Access Compliance Report

Public Rights-of-Way

Intersection ID: 28251	Main Street: PEMSWOOD_ST	Cross Street: SUMMER CLUB_RD	Location: SW
ADA ID: F1A0F8593F8E	Ramp Type: PerpDiag	Initial Pass/Fail: Fail	Overall Compliance: No
Severity Score: 35			
Codes/Mitigation Info/Possible Solution		Field Measurements/Component Compliance

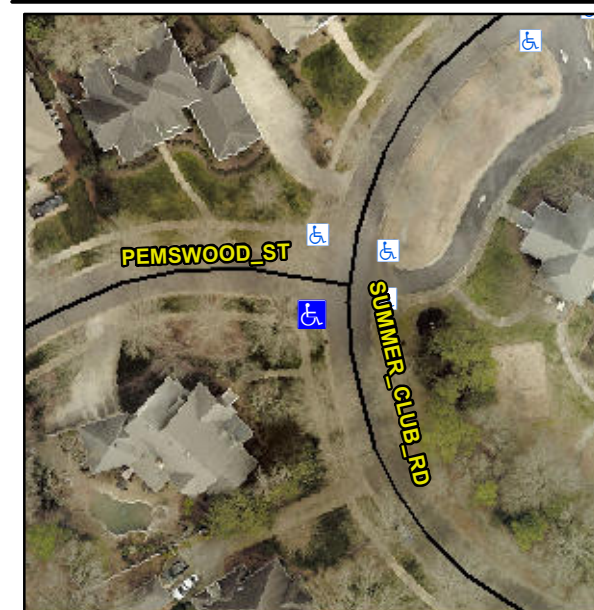
R304.5.1, R304.2.2, R304.5.3

Compliance	Description	Data	Compliance	Description	Data
N/A	Ramp Length (in)	97.0	No	Ramp Slope (%)	15.8
No	Ramp Width (in)	46.0	No	Ramp XSlope (%)	2.1
N/A	Flare Type LT	N/A	N/A	Flare Type RT	N/A
N/A	Flare Slope LT (%)	N/A	N/A	Flare Slope RT (%)	N/A
N/A	Flare Traversable LT?	N/A	N/A	Flare Traversable RT?	N/A
N/A	Landing Length (in)	N/A	N/A	DWS Provided?	N/A
N/A	Landing Width (in)	N/A	N/A	DWS Contrast?	N/A
N/A	Landing Slope (%)	N/A	N/A	DWS Length (in)	N/A
N/A	Landing X Slope (%)	N/A	N/A	DWS Full Width?	N/A
N/A	Landing Curb? (Y/N)	N/A	N/A	DWS Offset (in)	N/A
N/A	Shared Landing?	N/A			
N/A	Gutter Ponding?	N/A	N/A	Gutter Slope (%)	N/A
N/A	Gutter Lip Ht (in)	N/A	N/A	Gutter X Slope (%)	N/A
N/A	Painted X Walk1?	No	N/A	Painted X Walk2?	No
	X Walk 1 Direction	To E		X Walk 2 Direction	To N
N/A	X Walk 1 Width (in)	N/A	N/A	X Walk 2 Width (in)	N/A
	X Walk 1 Slope (%)	1.1		X Walk 2 Slope (%)	5.3
	X Walk 1 X Slope (%)	5.1		X Walk 2 X Slope (%)	1.6

Remove & Replace Curb Ramp With Two New Directional Ramps or Equivalent.
